GG119 ROAD SAFETY AUDIT RESPONSE REPORT

Project Title:	Proposed Warehouse, Cooper Bridge, Mirfield
Project Team:	John Cotton Group Ltd
RSA Report Stage	Stage 1
RSA Organisation:	Meraki Alliance
RSA Report Reference:	MAL/CPMRSA1Rev0
RSA Report Issue Date:	25 March 2025
Report Title:	Stage 1 Road Safety Audit Response
Reference:

This Road Safety Audit Response Report relates to a Stage 1 Road Safety Audit carried out on the proposed highway works required to access a proposed development of a warehouse on the former Cooper Bridge waste water treatment works, near Mirfield, Huddersfield (Planning Application Reference 2023/92448).

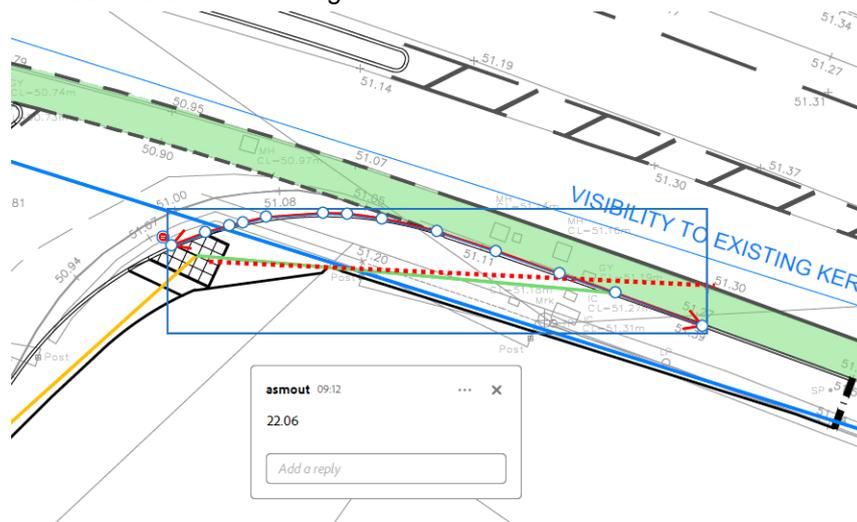
1-1 Problem

Location: Huddersfield Road Access.

Summary: Sub-standard visibility at uncontrolled crossings will increase the risk of pedestrian/vehicle collisions.

Detail: It is proposed to construct a new access onto Huddersfield Road, as part of these works an uncontrolled crossing will be provided. The details provided within the brief indicate that a maximum visibility splay of 1m x 17m can be achieved on the eastern crossing point. CD 143 Table E/5.2 states that the minimum measurement for a set-back (X distance) must be no less than 1.5m and the Y distance must be based on the speed of approaching vehicles. It is accepted that speeds will be low for HGV's turning into the site, but cars may well turn in at higher speeds resulting in an increased risk of pedestrian/vehicle collisions.

It is recommended that a minimum of 1.5m x 22m is provided which complies with DMRB set back distances and a stopping sight distances for approach speeds of vehicles of 20mph (MFS).

Recommendation accepted.

The proposed arrangement has been identified in consultation with the local highway authority in consideration of the planning application to date.

Notwithstanding this, the sketch below demonstrates that a pedestrian visibility splay of 1.5m x 22m can be achieved at this crossing.

The RSA Recommendation and Design Team Response are accepted.

The above sketch confirms that a 1.5x22m pedestrian visibility splay will be available to motor-traffic, when measured to the nearside edge of the mandatory cycle lane, which is in accordance with the RSA recommendation.

In addition to this, the Design Team have provided the following sketch that demonstrates that a 1.5x17m+ pedestrian visibility splay will be available to the nearside wheel-track (taken as min. 0.5m from kerb edge) of cyclists travelling in the cycle lane. This is in accordance with an SSD of 17m, as set out in LTN1/20, based on a 20kph cycle design speed, which is considered to be robust for a left turning cyclist turning into the junction.
